Planning and Zoning Board

CASE NUMBER: Z16-050 (PLN2016-00670)
LOCATION: 3100 block of North Recker Road and 5700 through 5900 block of Longbow Parkway
GENERAL VICINITY: Located south of Loop 202 and west of Recker Road
REQUEST: Site Plan Review
PURPOSE: To authorize development of a group commercial center.
COUNCIL DISTRICT: District 5
OWNER/APPLICANT: Dover Associates LLC./Earl, Curley & Lagarde, P.C.
STAFF PLANNER: Andrew Spurgin, Principal Planner

STAFF RECOMMENDATION: Approval with conditions

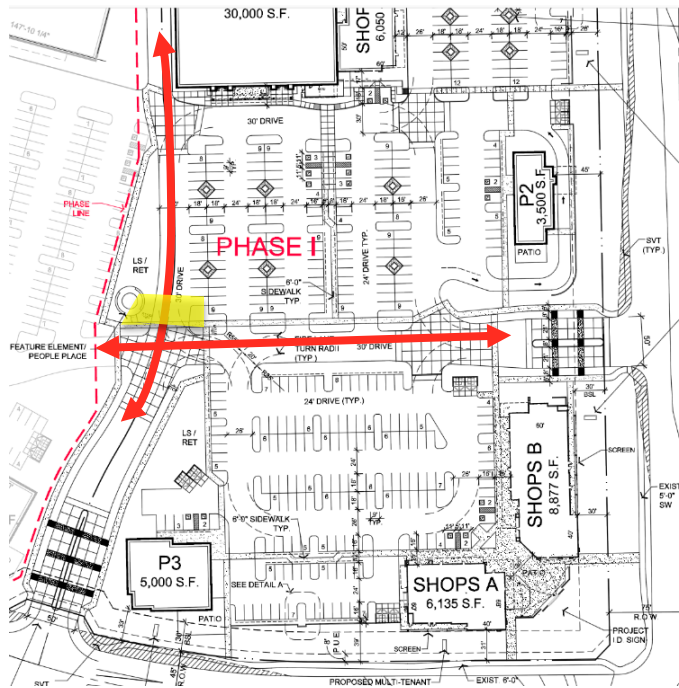
Given the Mixed Use Activity District designation in the General Plan and the available 38 acres of additional land within the Phase 2 development area, the preference of staff is for development of a park-once setting that is walkable and creating a unique experience that differs from typical strip commercial and pad development.

In discussions with the applicant, staff was informed that the 30,000 square foot retail anchor is driving many project considerations and is essential to the success of the overall project. The design team has responded well to staff concerns and suggestions with site plan updates to establish a setting with civic spaces, pedestrian circulation that is separated from vehicular traffic and interesting streetscape presence. While a more urban form is desirable, staff acknowledges the responsiveness of the design team, the need to provide commercial retail and services to this section of Northeast Mesa and opportunities to establish urban formats within other sections of the surrounding Longbow PAD.

An additional public space is shown along the west side of Phase 1 where the main east-west and north-south driveways intersect, shown in the plans as “feature element/people place.” The project narrative provides images of how this public space inside the parking lot could function. The preference of staff would be to have such a feature closer to the buildings but the applicant has indicated that the parking field for the retail anchor tenant is critical to project success and it must be kept as planned.

Relative to vehicular circulation adjacent to the “feature element/people place,” staff has encouraged the applicant to monitor potential circulation conflicts between trucks, vehicles using the drive aisle and parking vehicles and opportunities for pavement treatments, signage or curb extensions to provide awareness of multiple operational characteristics of this location. The applicant has proposed using a stop sign at the intersection and decorative pavement in the four-way driveway intersection as a demarcation of this different location. All crosswalks through the development are requested to provide pavers, decorative pavers or stamped concrete to ensure demarcation of pedestrian space (condition #10). It is recognized that as phase 2 of the project continues the development of the retail center to the west and, when built, it appears that trucks will use the perimeter driveway around the edges of phase 2 rather than the north-south drive aisle discussed above.
